# ARCHITECT'S SUPPLEMENTAL INSTRUCTIONS

Date Issued:	May 19, 2020
Project:	Intermountain Healthcare  Tooele Valley Dialysis Clinic Expansion 2356 North 400 East, Suite #102 Tooele, Utah 84074
Architect's Supplemental Instructions:	ASI #6
To:	Saunders Construction 1113 South 500 West Bountiful, Utah 84010

RE: ASI-006 - Existing Waste Drops from Level 2

A113

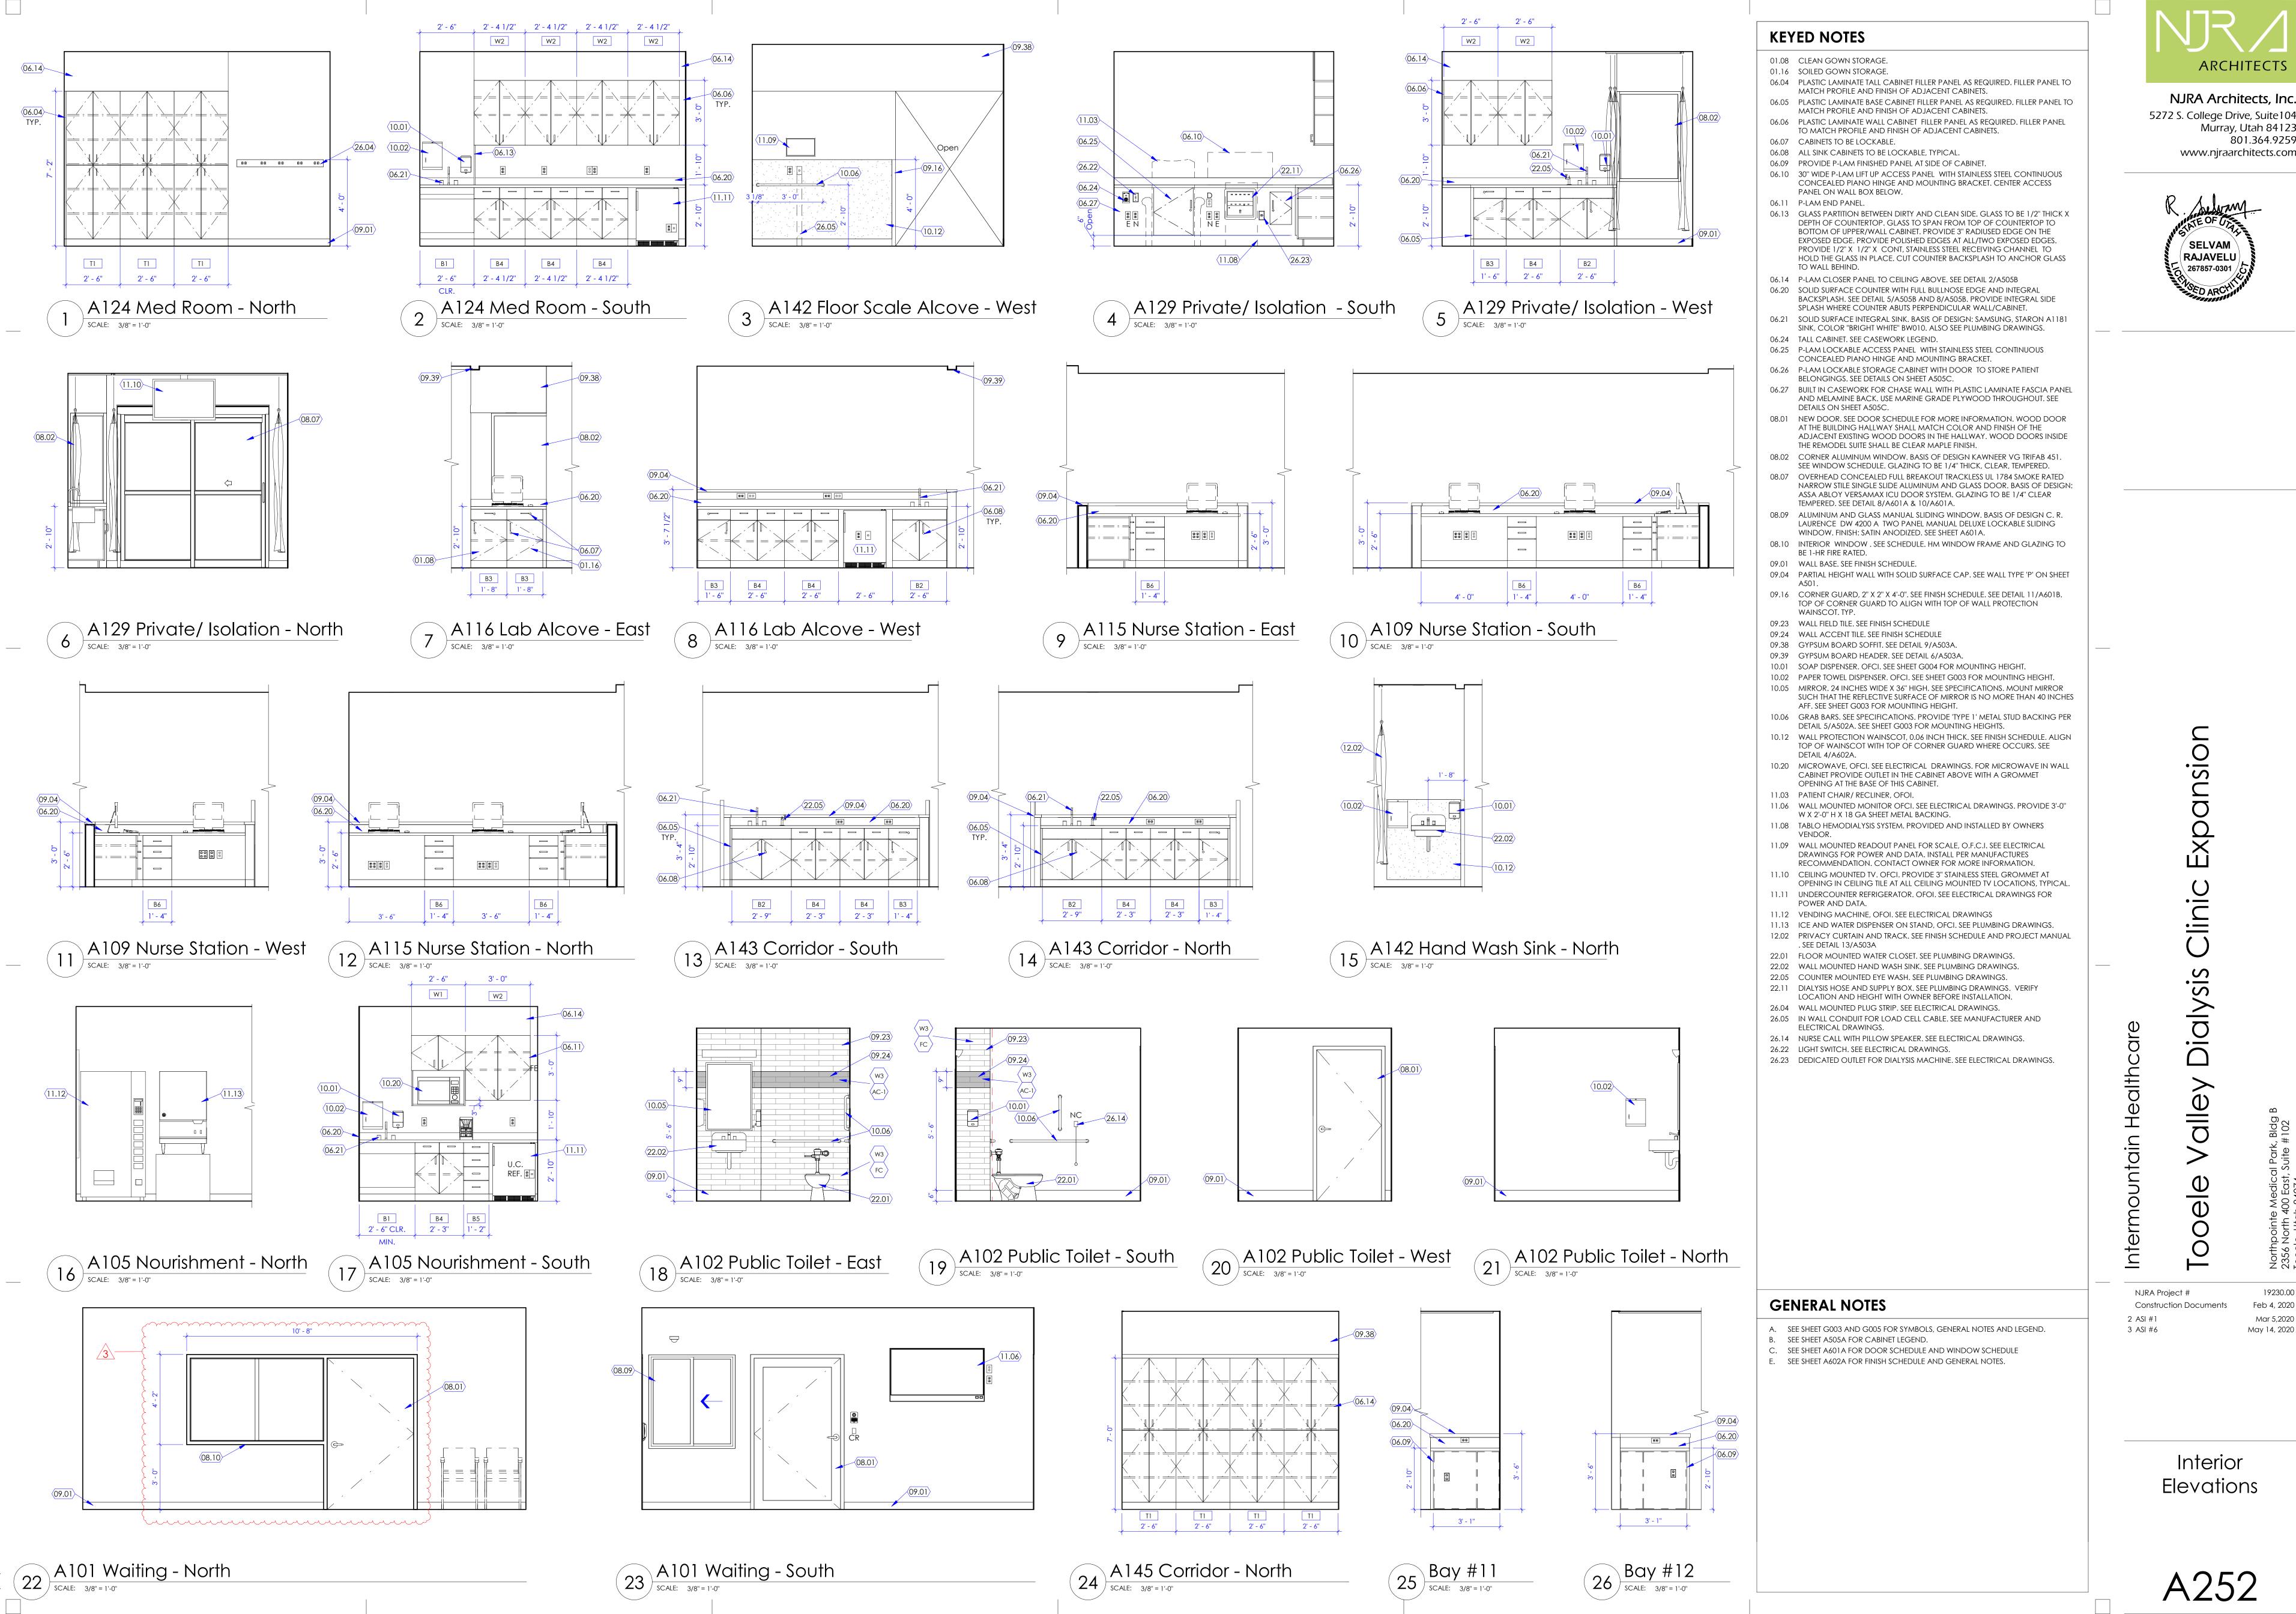
Item Number	Description
1	As requested by the Owner main entrance door A101A has been moved west and merged with the new hollow metal window W1 shown in the plan. See attached revised sheets with revisions shown clouded for more information on this change.
2	As notified by the contractor through RFI #01- some existing waste lines from upper floor were found to be located inside the demolished walls. These needed to be re-routed in coordination with the new layout of the suite at level 1. See attached revised plumbing & architectural sheets with revisions shown clouded for more information.
3	See attached Mechanical & Plumbing ASI #6 from VBFA Engineers.

MH101

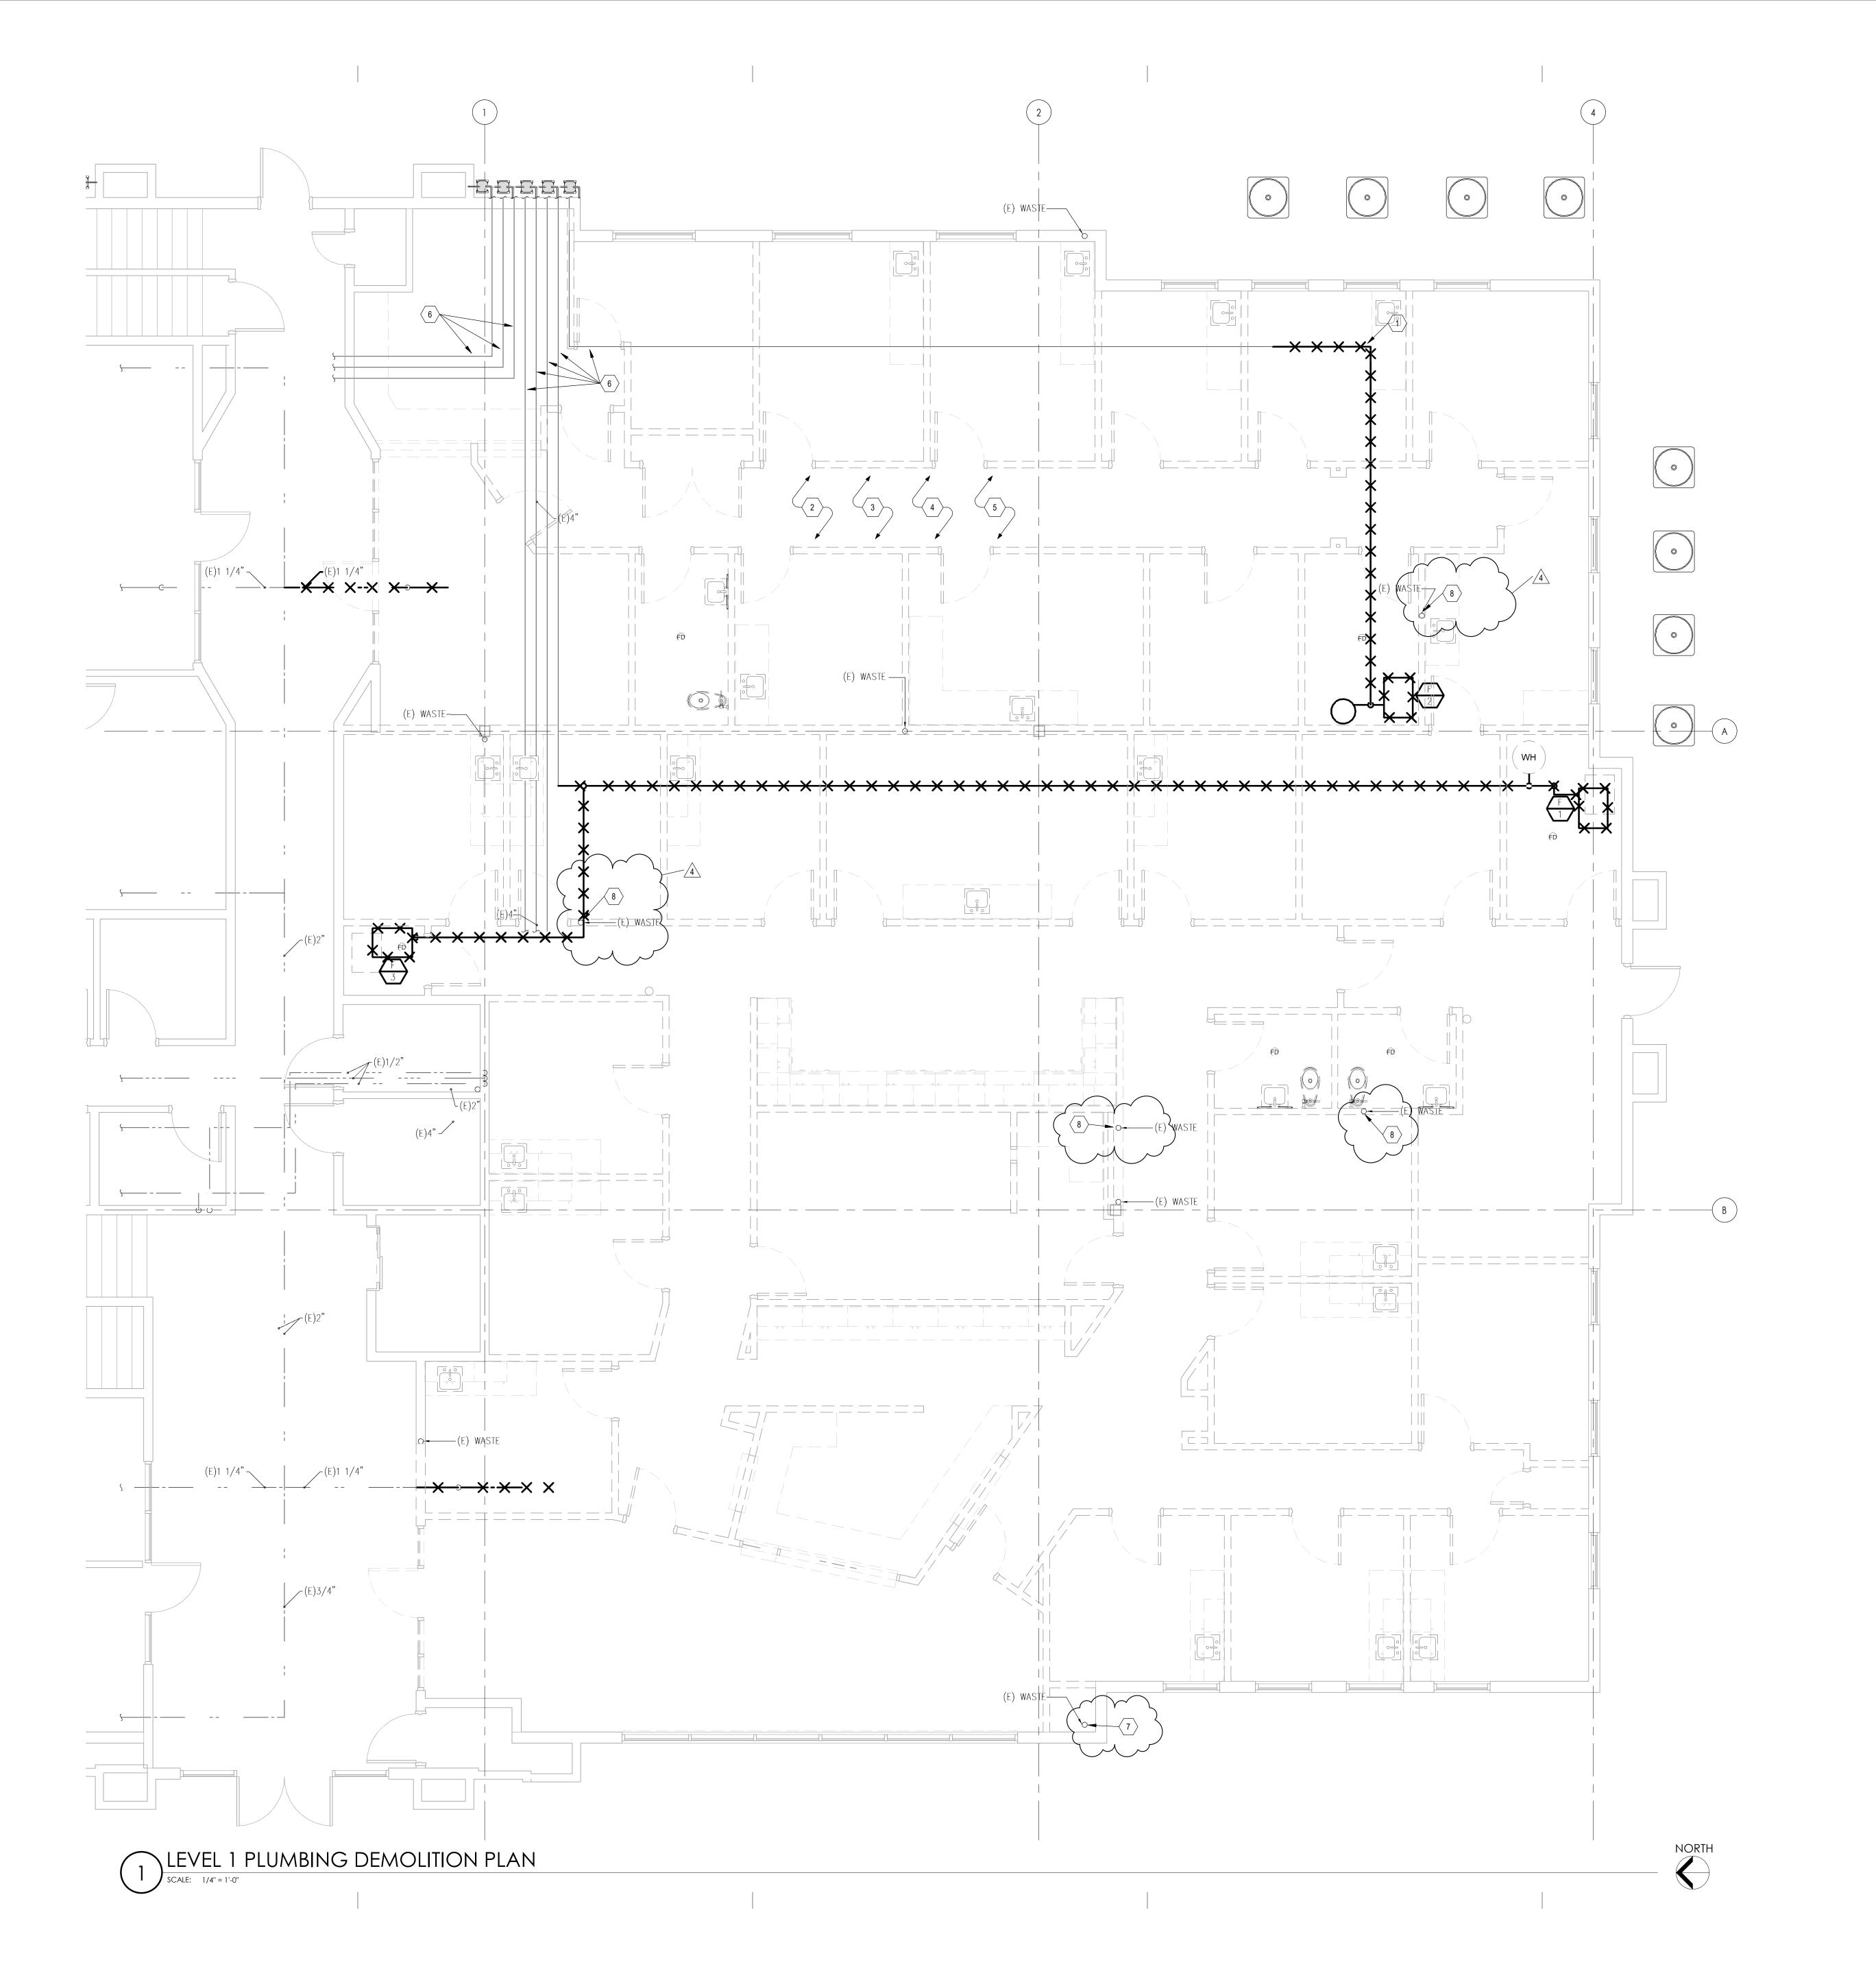
### SHEET - MH101 - LEVEL 1 MECHANICAL PLAN

1. Offset on south duct off of FUR-2 removed.

PD101

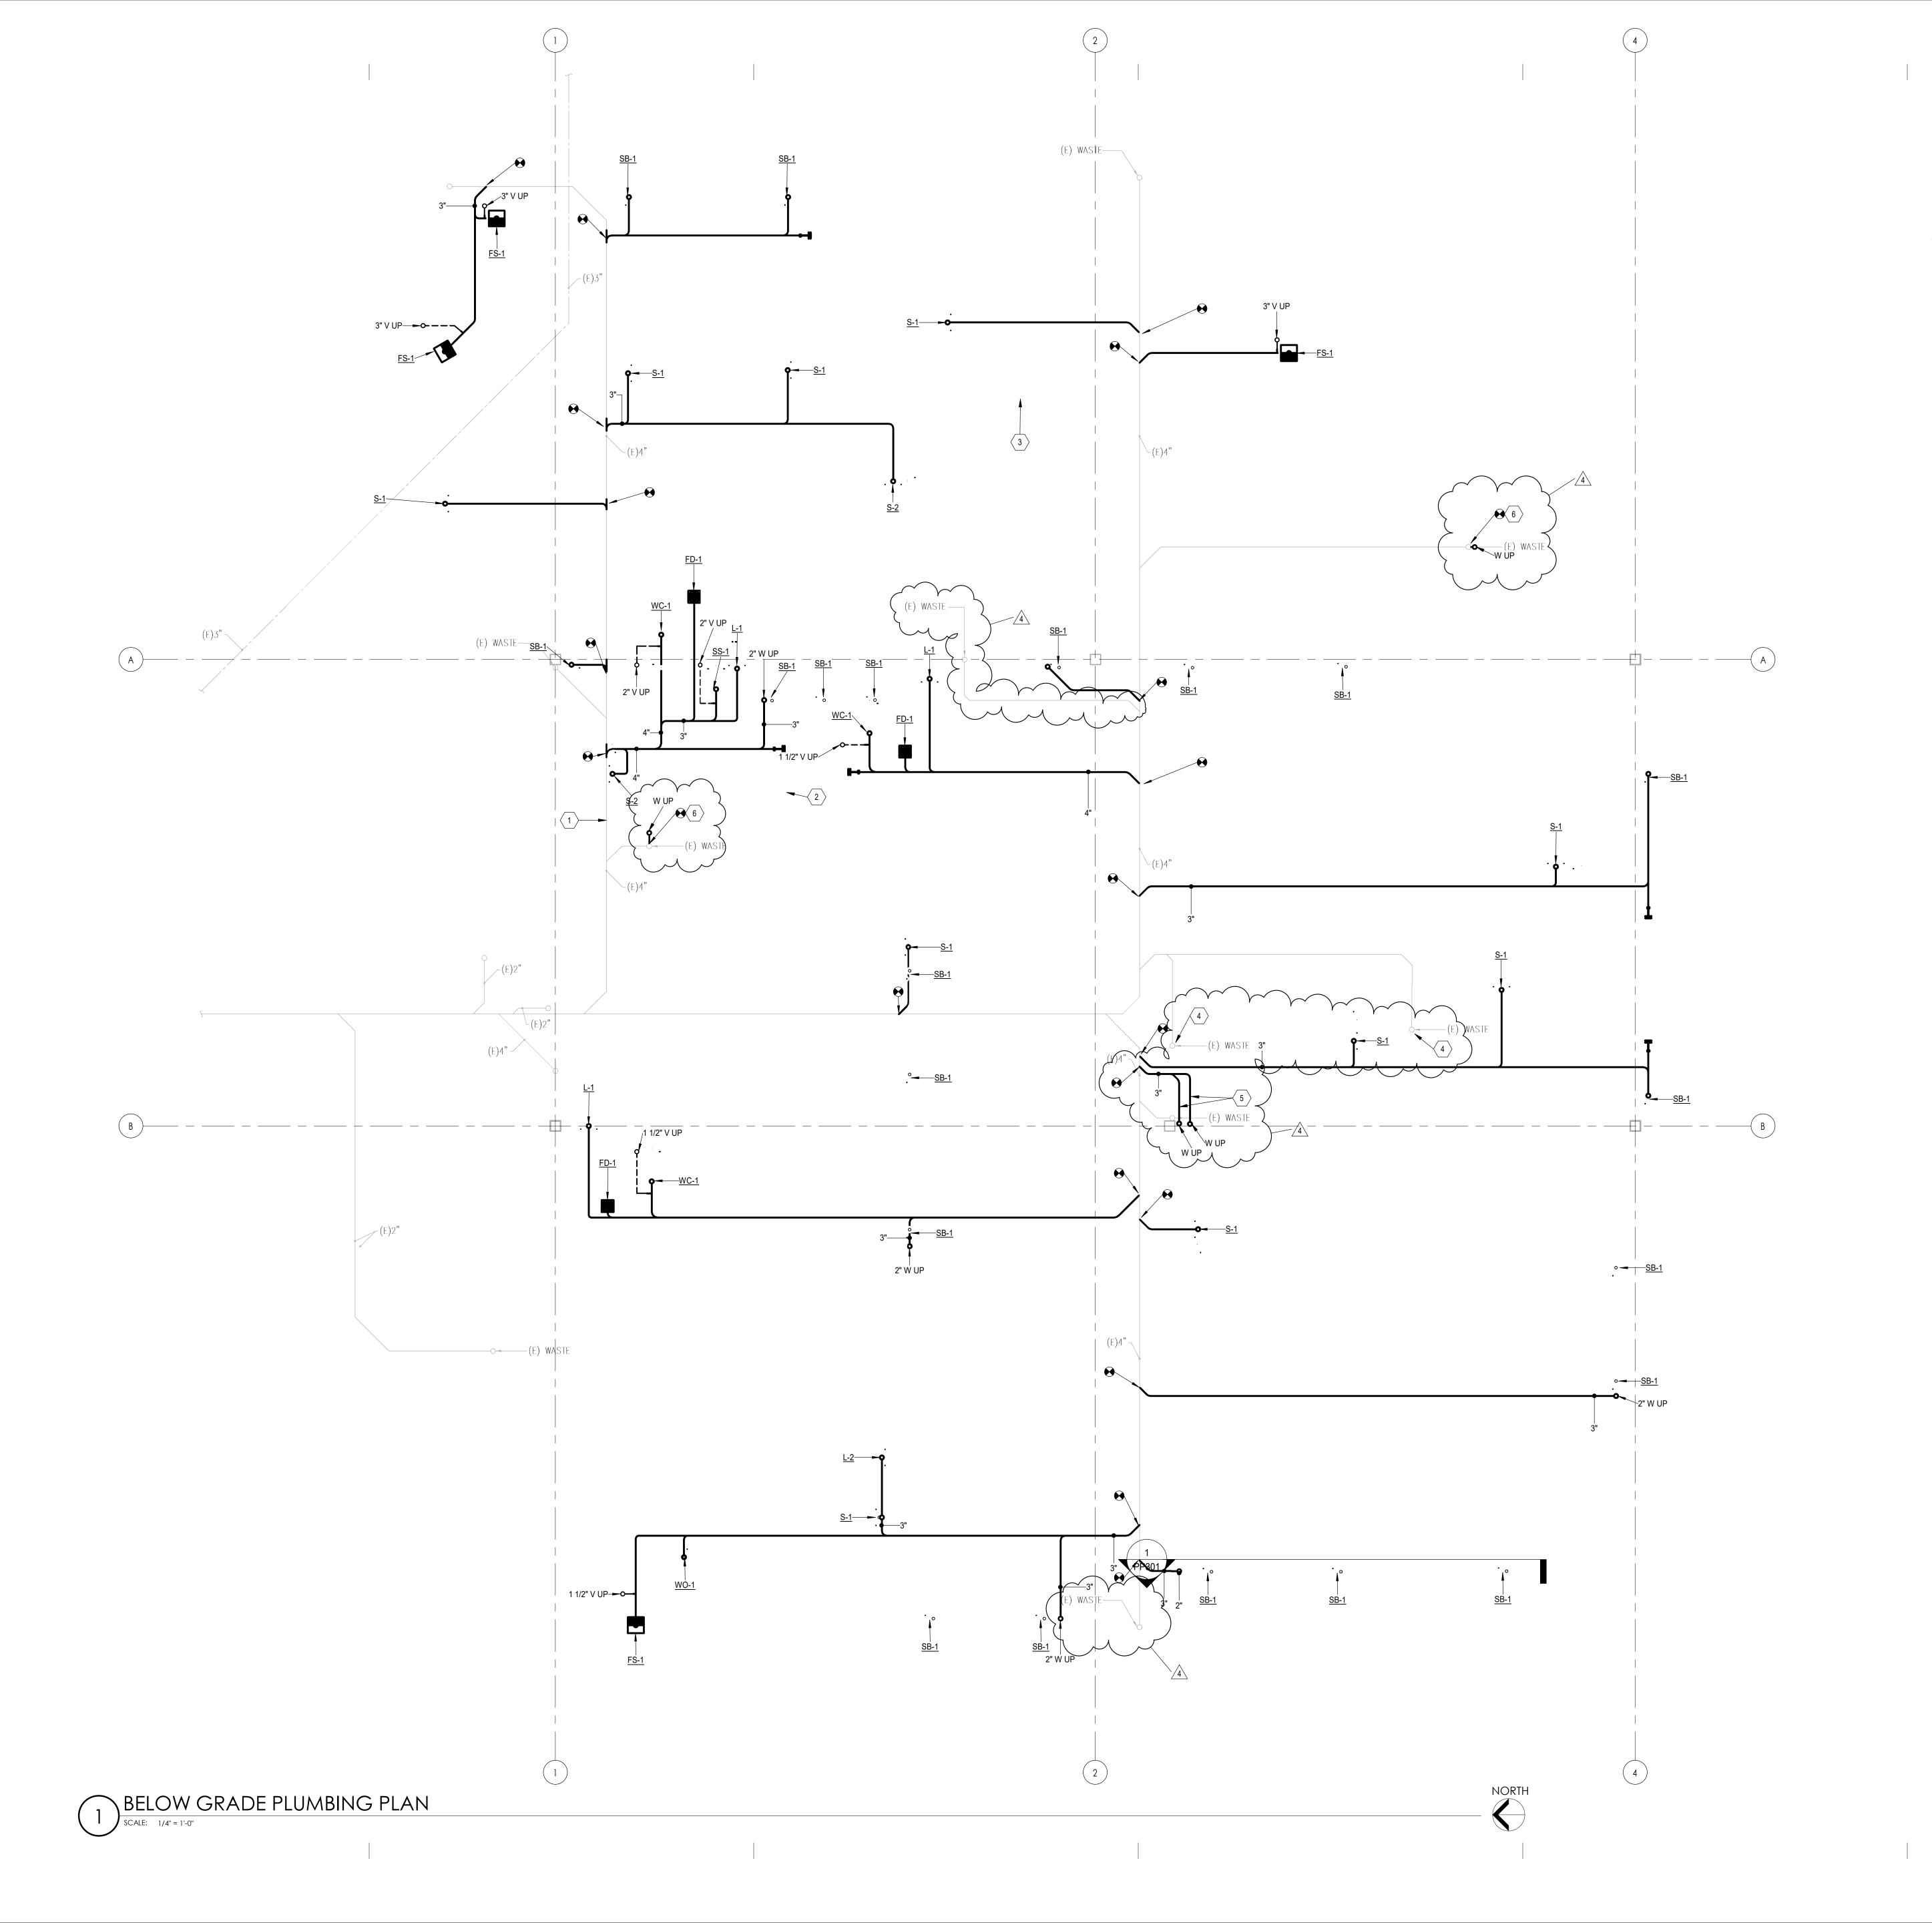
## SHEET - PD101 - LEVEL 1 PLUMBING DEMOLITION PLAN

- 1. Keyed note 7 added.
- 2. Keyed note 8 added.
